UNITED STATES DEPARTMENT OF COMMERCE United States Patent and Trademark Office Address: COMMISSIONER FOR PATENTS P.O. Box 1450 Alexandria, Virginia 22313-1450 www.uspto.gov

APPLICATION NO.	FILING DATE	FIRST NAMED INVENTOR	ATTORNEY DOCKET NO.	CONFIRMATION NO.
10/588,536	08/07/2006	Fernando Garofoli	06170-PCT-PA (0030.0567)	9569
Hades Pe	ssint Katz,	EXAMINER		
901 Dulan	en Valley K	md :	FULTON, KRISTINA ROSE	
Suite 400	J		ART UNIT	PAPER NUMBER
Baltimore,	eg Valley Ro MD 21204		3673	
			MAIL DATE	DELIVERY MODE
			09/29/2008	PAPER

Application No.	Applicant(s)				
•	10/588,536	GAROFOLI, FERNANDO				
Office Action Summary	Examiner	Art Unit				
	KRISTINA FULTON					
- The MAILING DATE of this communication a		3673 the correspondence address				
Period for Reply						
A SHORTENED STATUTORY PERIOD FOR REPLY IS SET TO EXPIRE 3 MONTH(S) OR THIRTY (30) DAYS, WHICHEVER IS LONGER, FROM THE MAILING DATE OF THIS COMMUNICATION.  - Extensions of thre may be available under the provisions of 37 CFR 1.136(a). In no event, however, may a reply be timely filed enter SIX (6) MONTHS from the mailing date of this communication.  - If NO period for reply is specified above, the maximum statutory period wi

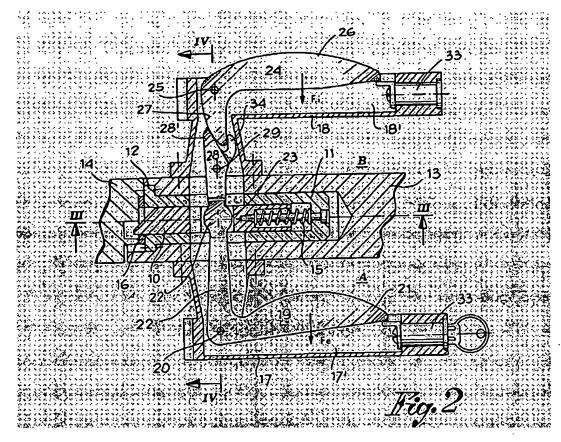
Claims 1-15 are rejected under 35 U.S.C. 102(b) as being anticipated by Pedersoli (DE4009764). "As best understood" Pedersoli shows internal and external handles (17 and 18) having an opening lever (22 or 27) and an opening button (26 or 21). The handle further include a vertical lever (28) having a fork (29). The device includes a spring (15) within a housing (11) and a latch mechanism (10). The door handle further shows a cylindrical chamber (at each end of handle for cylinder 33). The handle includes a cylinder (33) for locking the handle with a key (see illustration below). The handle is an L shape. See the Pedersoli device below.
